P&Z STAFF REPORT

Board of Appeals Meeting, August 11, 2020

Case: **V20-0026 – 1155 Mount Vernon Highway**
Staff Contact: Madalyn Smith (msmith@sandyspringsga.gov)
Report Date: July 31, 2020

Request for a Variance from Sec. 5.4.3.D., “Ground Floor Elevation,” of +/- 3.29’ (approximately 3.5’) below the required 0’ elevation minimum.

Sandy Springs Arborist:

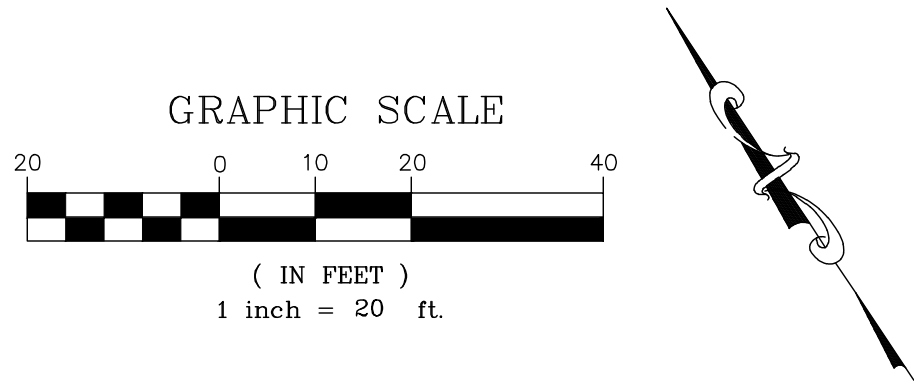
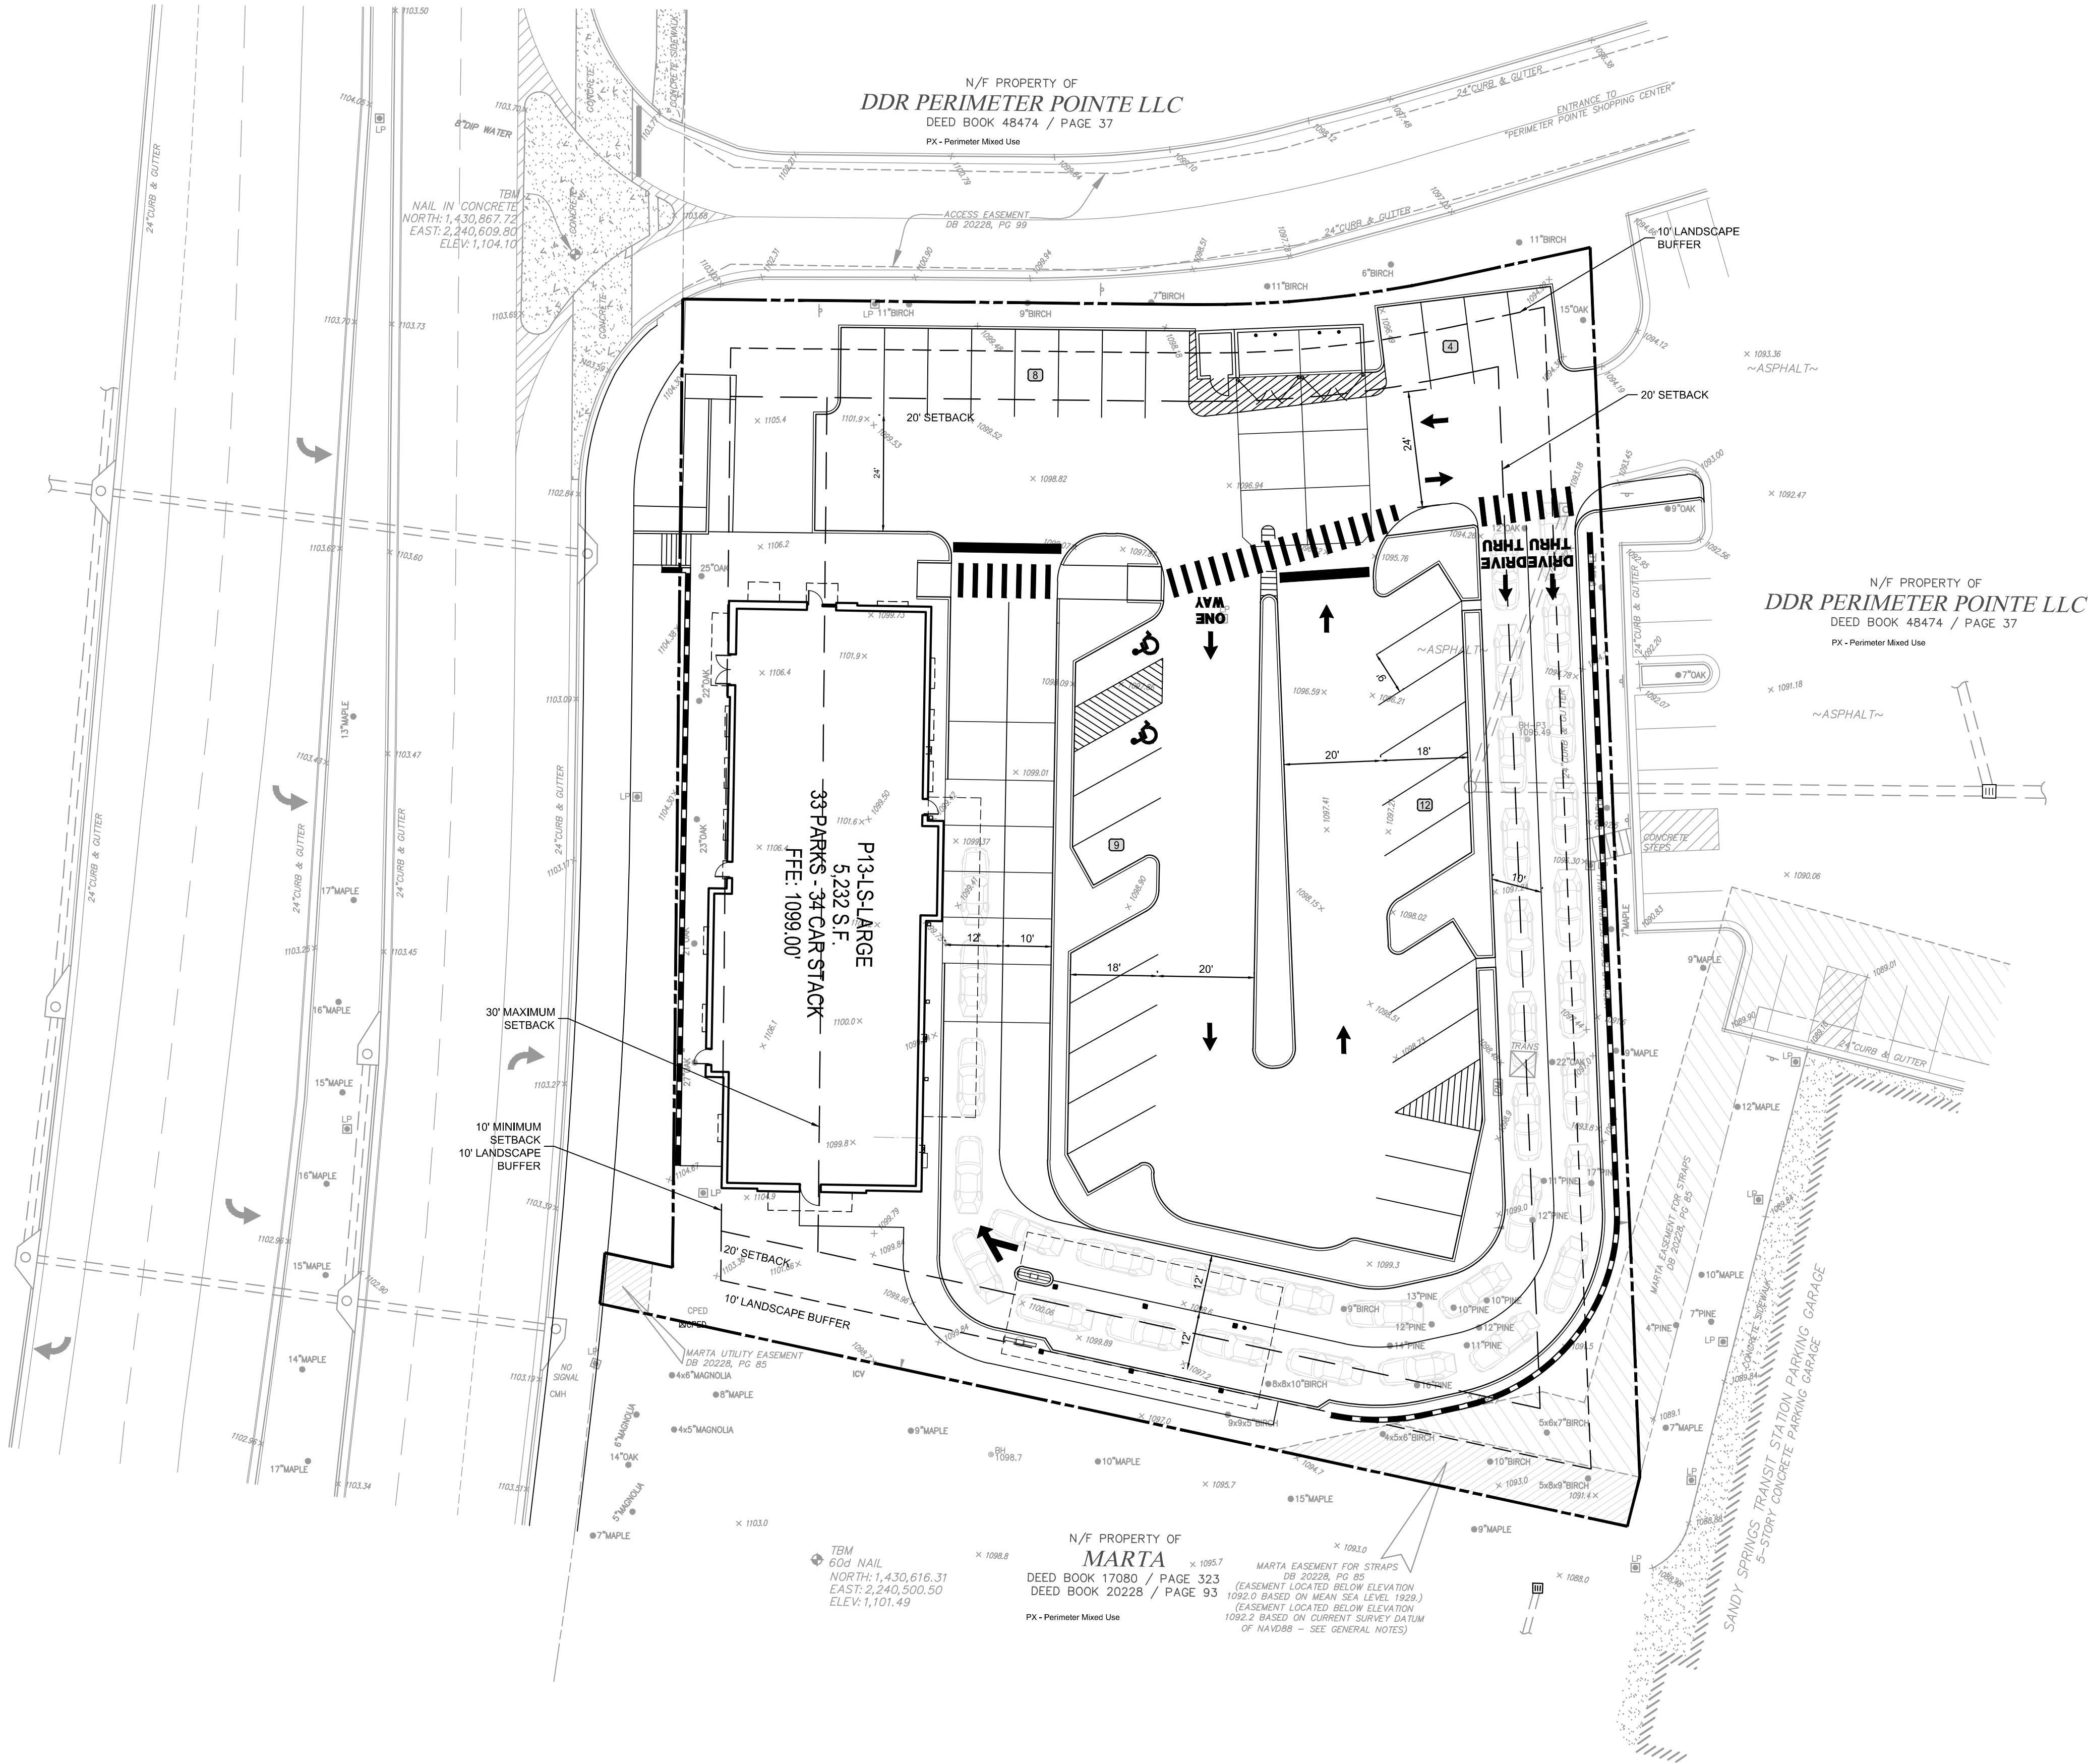
I'm also concerned about the impact on the existing oaks that I note on the attached. I don't know if [the Sandy Springs Arborist] has looked at this. I'm not sure I'm clear on the purpose of the wall and little access way along the west side of the building. It would seem that moving the wall east five or six or so feet and making it a foundation wall for the building would work better and give the trees a better chance. That would need more study and investigation, though.

The CRZs for the Oaks would range from 28' to 34' (radius) so the impact shown would almost certainly kill these Oaks, one of which is a Landmark Tree. I agree relocating the wall east would at least give the trees a chance, though they would still be impacted 40% or more. Our threshold for lost/destroyed trees are 25%. There might be an important purpose to the wall that I'm overlooking, but the less impact, the better for these trees.

SITE PLAN

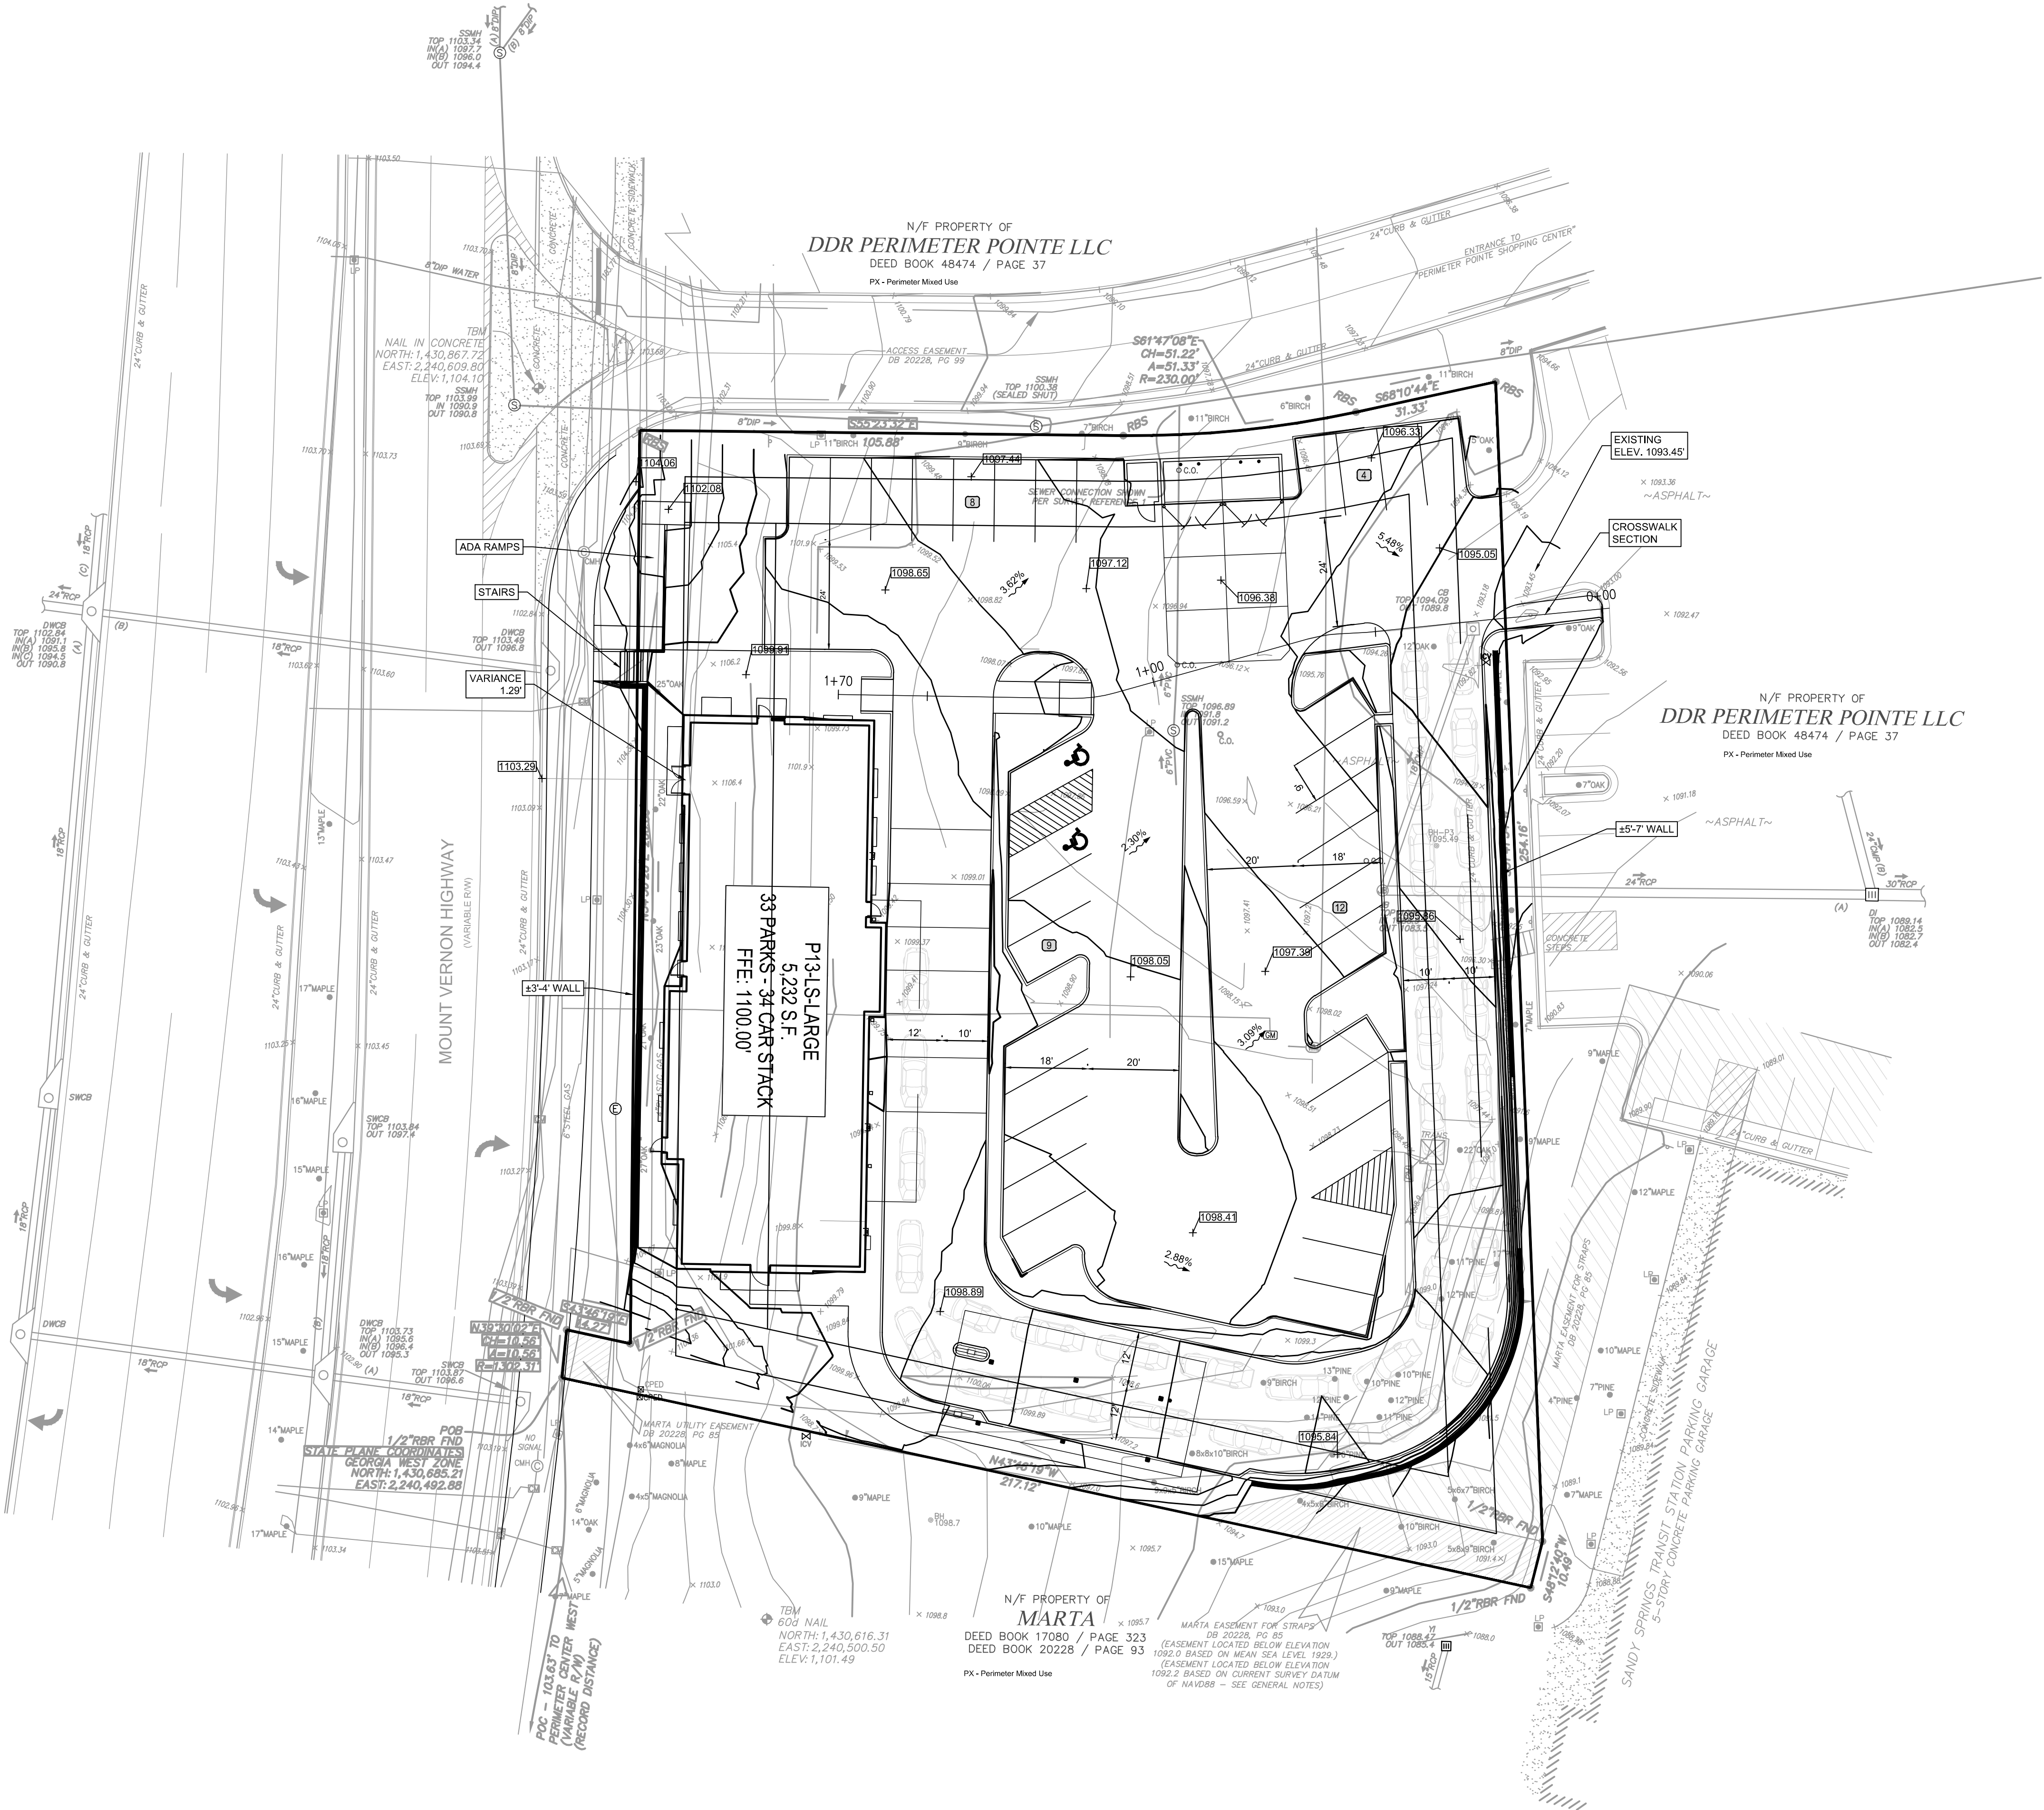
[The applicant] should be able to raise the finished floor level of the new building from the 1100.00 they show on the grading plan (which I assume is correct, rather than the 1099.00 they show on the site plan) to 1101.29 or a little higher and avoid the variance altogether.

The FFE elevation change would mean increasing the grade on the entry drive to 5% or slightly more for its entire run and would also require relocating the accessible parking to be adjacent to the north side of the building. It will also mean regrading the parking bays some.

While the rationale for this variance is accessibility, this plan does not provide for an accessible route from either the MARTA entrance or the accessible parking they show, so the accessible parking needs to be relocated, anyway. An accessible route to the MARTA entrance would be desirable but, in this situation, appears impractical, since it would likely need to cross both MARTA and the shopping center properties. It might be possible if they significantly alter their site to work it out but it would still very likely require an easement on MARTA property.
